SUZUKI
2-Stroke
Service Bulletin
Index

Bulletin No: GT-1
Date: May 1, 1975

Subject GT750 COOLING SYSTEM

Subject: GT750 OIL STARVATION

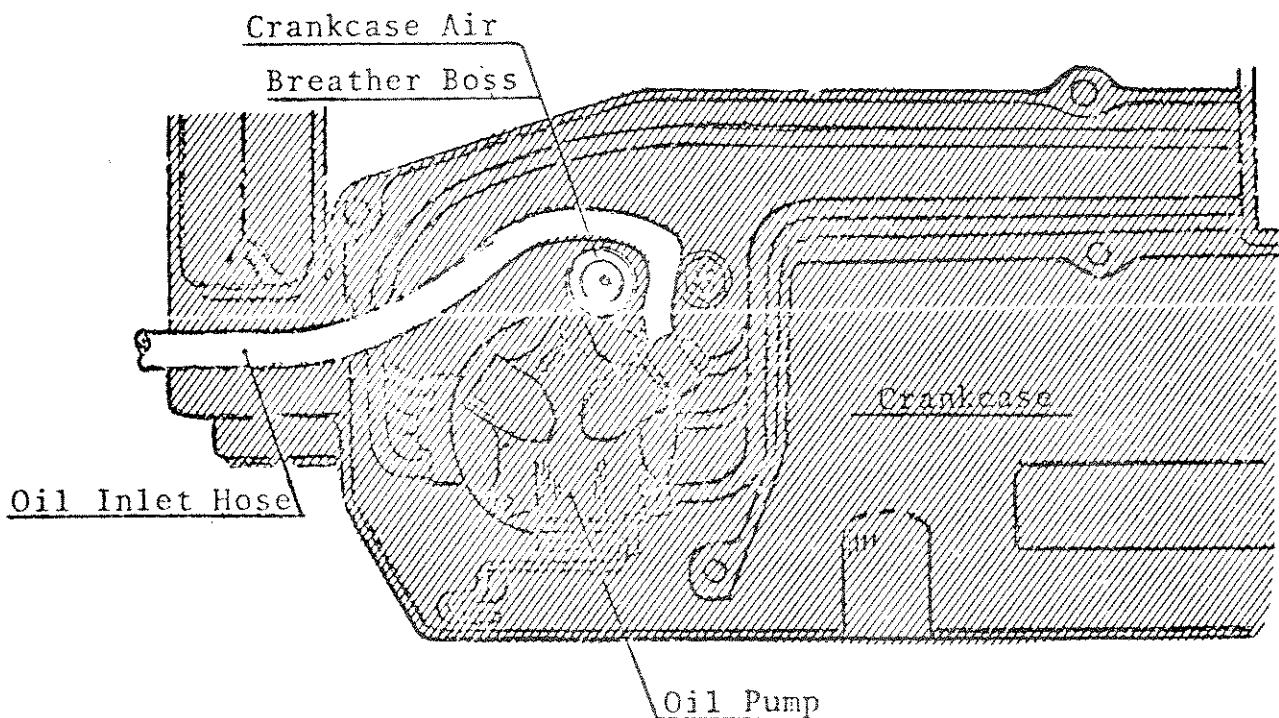
If care is not taken it is possible to pinch the inlet line from the oil tank to the oil pump when installing the oil pump cover. Pinching this line closed will result in no oil getting to the oil pump, or to the engine. Naturally this can cause a multitude of problems due to lack of lubrication.

1. Take special care that the oil pump inlet hose is routed around the crankcase air breather boss before installing the oil pump cover.
2. Before tightening down the screws holding the cover, check that the cover seats flush against the crankcase, without any gaps. If there is a gap, this would indicate that the hose might be pinched between the breather boss and the cover.
3. After tightening the screws, start the engine and check at the lines for any evidence of oil starving.

1. STARTER CLUTCH HOUSING

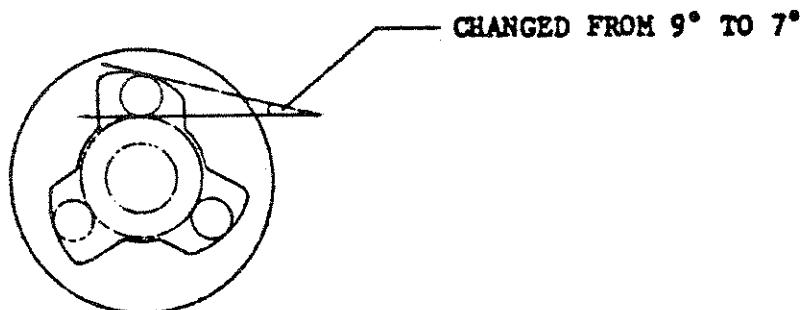
The wedge has been altered as shown in the illustration.

3. STARTER CLUTCH GEAR

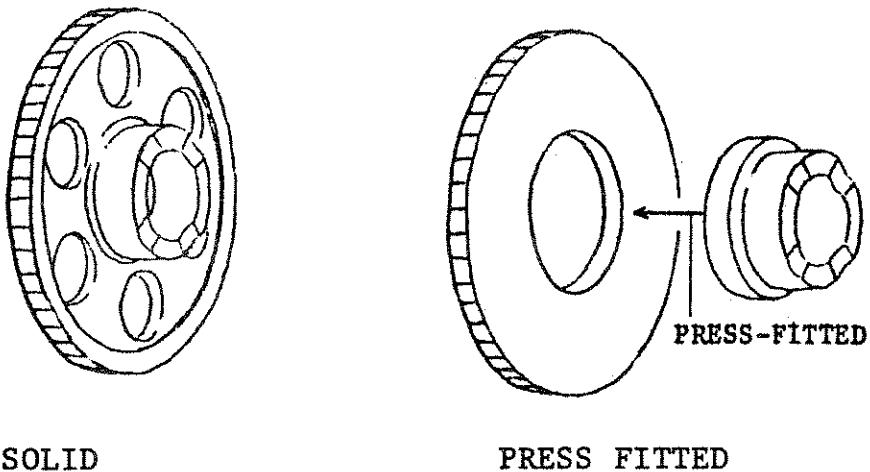
The hub on the starter clutch gear on which the starter clutch rollers run has been changed from a solid type to a press-fitted type as shown below.

4. CRANKSHAFT LH OIL SEAL

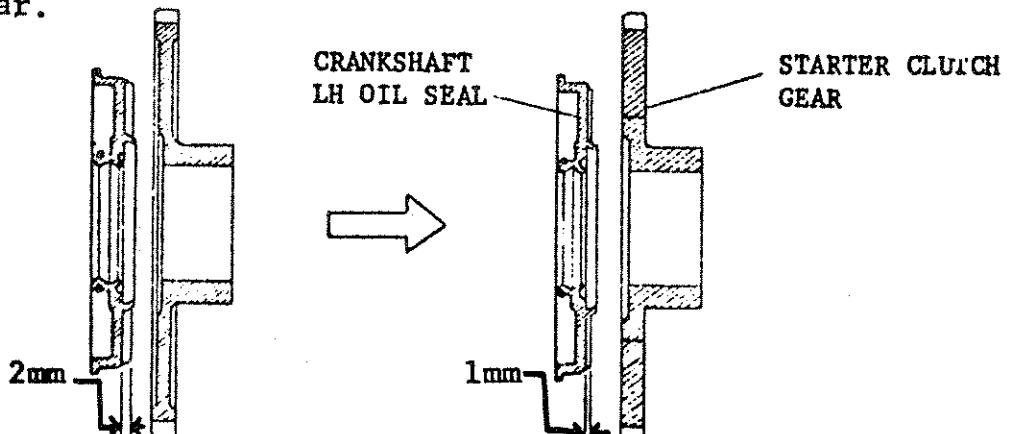
In connection with the modification of the starter clutch gear the thickness of the gear is evened so as to have enough contact surface around the hub being press-fitted.

In addition, the height of the ribs on the crankshaft oil seal have been lowered by 1 mm in order to clear the starter clutch gear.

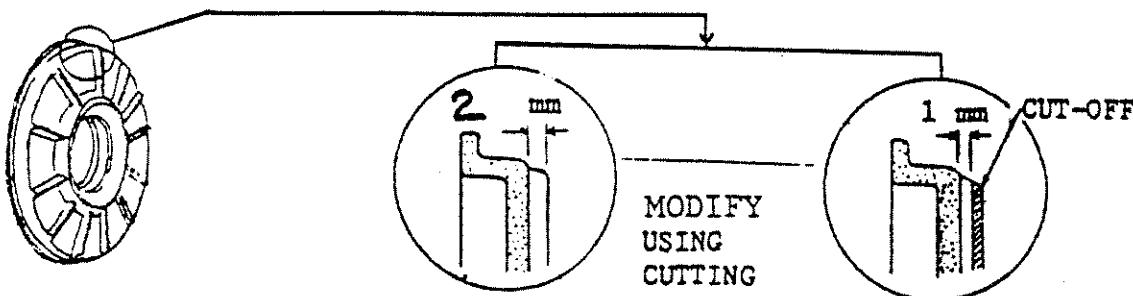
On future parts orders only the new type starter clutch parts will be supplied. However, the old type LH crankshaft oil seal will still be supplied until such time as the existing stock is exhausted. Therefore, when the old oil seal is retained in the unit and the starter clutch is modified or replaced, it is necessary to check the rib height of the oil seal and modify the same as shown.

MODIFY
USING
CUTTING
PLIERS OR
KNIFE.

Subject: GT750 CRANKSHAFT MODIFICATIONS

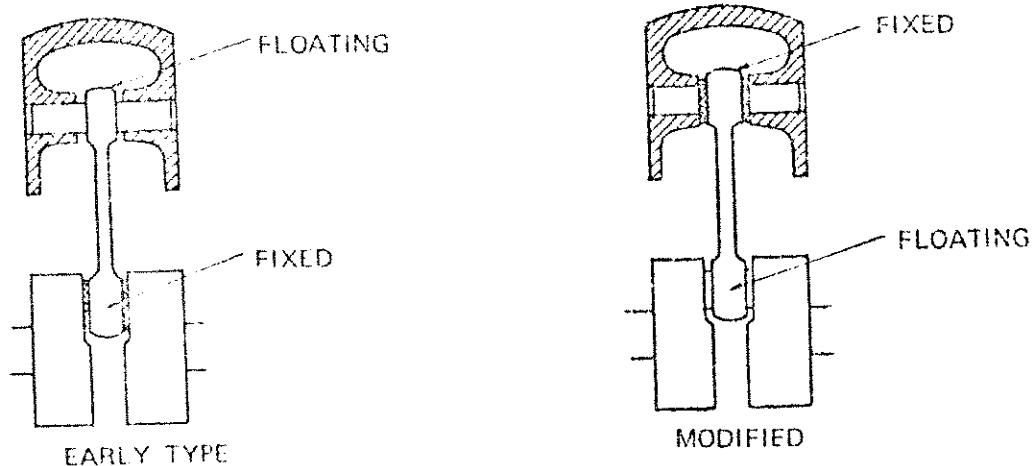
Side movement of the connecting rod is restricted on the small end, and the big end has been changed to a floating type as shown in the illustration below.

A) Crank Wheels:

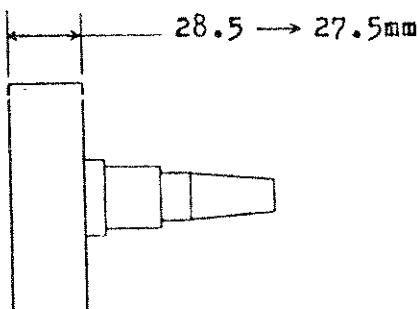
The width of the crank wheels has been reduced from 28.5mm to 27.5mm.

B) Pistons:

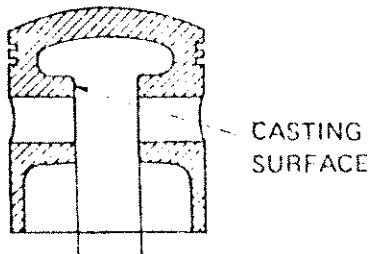
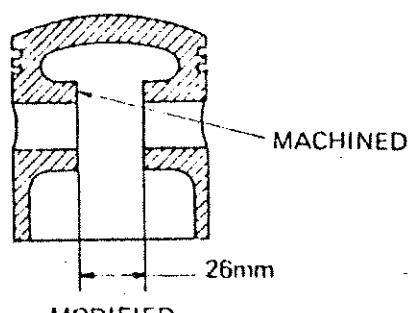
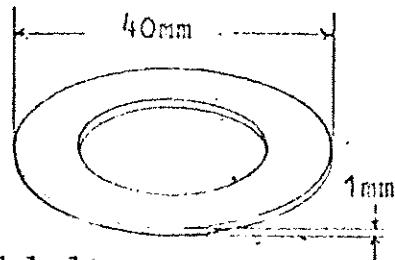
The pistons inside surface has been changed from a casting surface to that of a machined surface. The inside dimension between the wrist pin bosses has also been changed.

F.) **Cylinder gasket:**

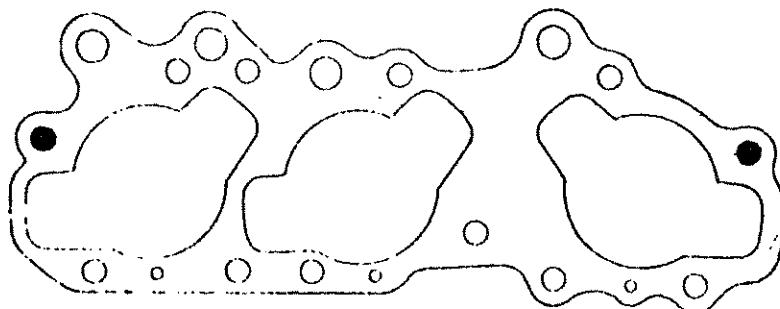
Two holes in the gasket have been enlarged from 11mm to 12.5mm in diameter to match the new type stud bolts.

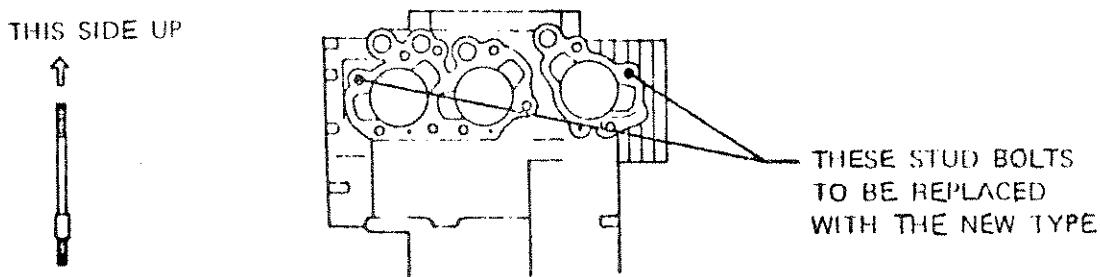
2) In order to achieve proper alignment of the connecting rod with the center of the cylinder bore, the necessary stud bolts should be replaced with the new style as shown below.

MODIFICATION:

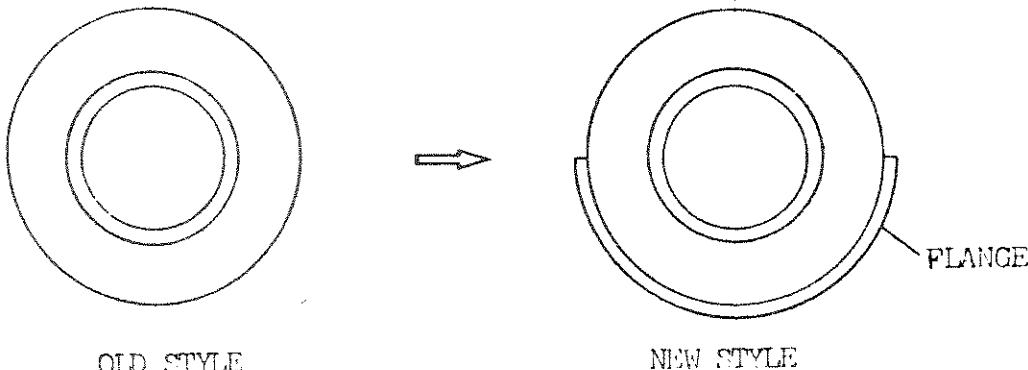
To provide a more positive method of positioning the right inboard oil seal, a metal flange has been added to the seal.

The new style seal's flange eliminates the old style seal's positioning "C"-ring (Part No. 09390-78003). The flange of the oil seal should be placed in the "C"-ring's crankcase groove when positioning the crankshaft assembly in the lower crankcase half.
